Technical Service Bulletin: TSB130186

Released Date: 04-Feb-2014

Dual Impeller Water Pump Orifice and Duckbill Changes

07500019

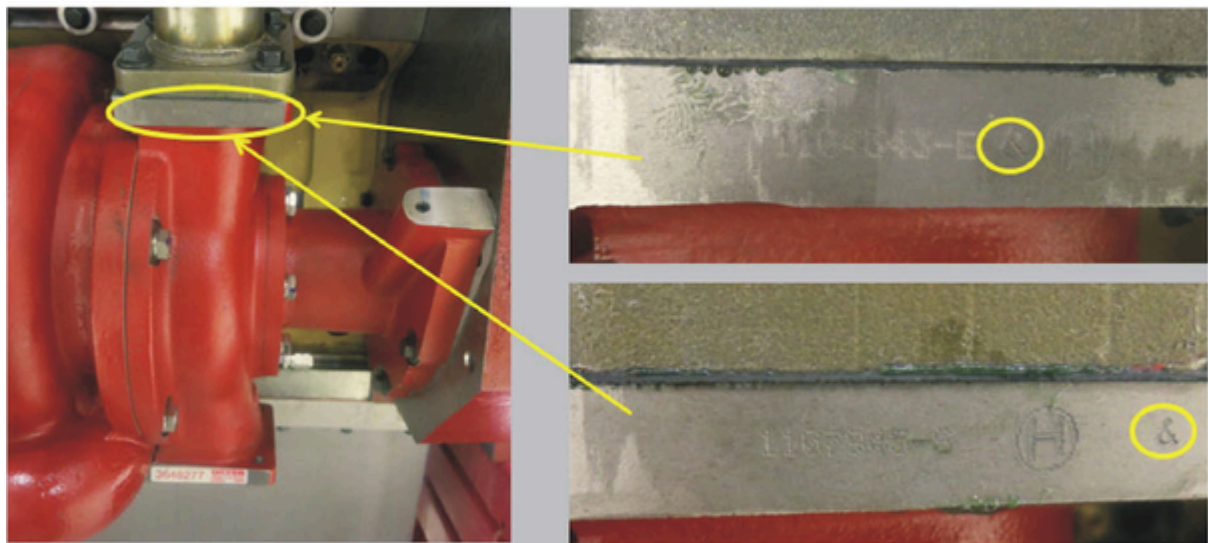
This document announces the release of an improved dual impeller water pump for QSK 38, 50, and 60 engine models as shown below.

- A reduction in diameter in the internal oil orifice that is used to supply the bearings with oil.
- A more robust debris shield, to prevent dirt ingress through the weep hole.

The oil feed orifice previously had a higher flow which exceeded the oil requirement for the bearings and caused oil to leak past the oil seal.

The debris shield (duckbill), has been redesigned to be longer and a more secure fit for robustness.

For four weeks prior to implementation, the new part numbers pumps were produced with the new sized orifice and existing part numbers. These pumps can be identified by the "&" after the serial number stamped on the pump body, as shown above.
